**HEALTH & SAFETY EXECUTIVE  
NUCLEAR DIRECTORATE  
ASSESSMENT REPORT**

**Step 2 GEH – ESBWR Civil Engineering and External Hazard Assessment**

HM Nuclear Installations Inspectorate  
Redgrave Court  
Merton Road  
Bootle  
Merseyside L20 7HS

**Figure 1 Comparison of ESBWR Design Spectra with various UK Site Response Spectra**

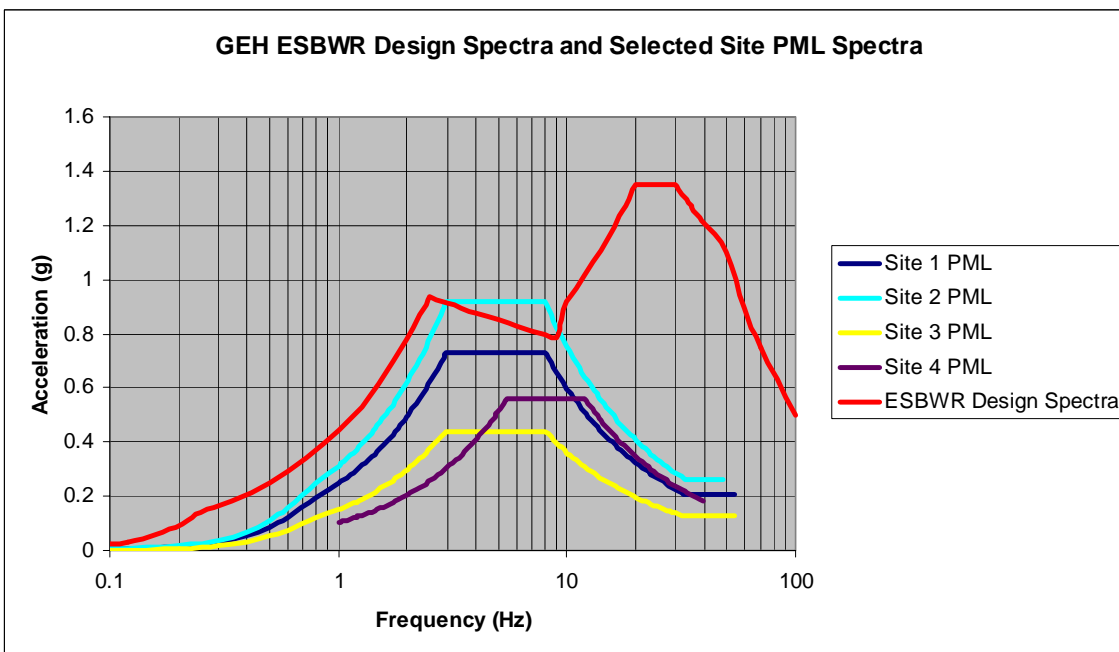
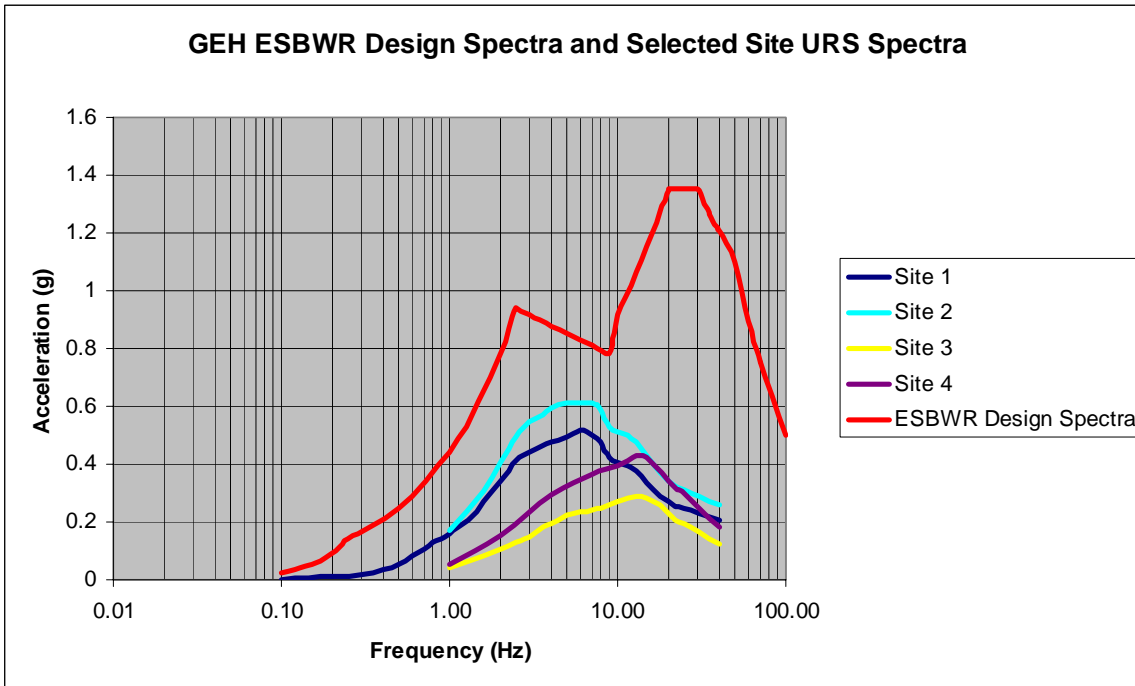
GEH claim that the ESBWR design has addressed these SAPs, Ref 5. The compliance document signposts to the External Hazards that have been considered directly in the design basis of the plant, and also provides a synopsis of those hazards which will be considered as part of the site licence application. The approach adopted is reasonable at the Step 2 stage, however, a more considered view over the application into the UK situation will be required at the Step 3 assessment, and for the Step 4 considerable attention will be required in this area. Figure 1 in this report shows a basic comparison of the seismic design basis for the ESBWR as compared against a selection of 4 UK sites. As can be seen, it is not apparent that the design envelopes all sites from this simple comparison.

**Observation 12** *The statements in the PSR are misleading “The analysis demonstrates that there is a high confidence level, that the risk-significant ESBWR structures and components, can withstand an earthquake with a peak ground acceleration of at least 0.5g. For design purposes the safe shutdown earthquake value is 0.3g.” The design spectra is actually an amalgam of sites enveloped together and the pga term has little actual meaning*
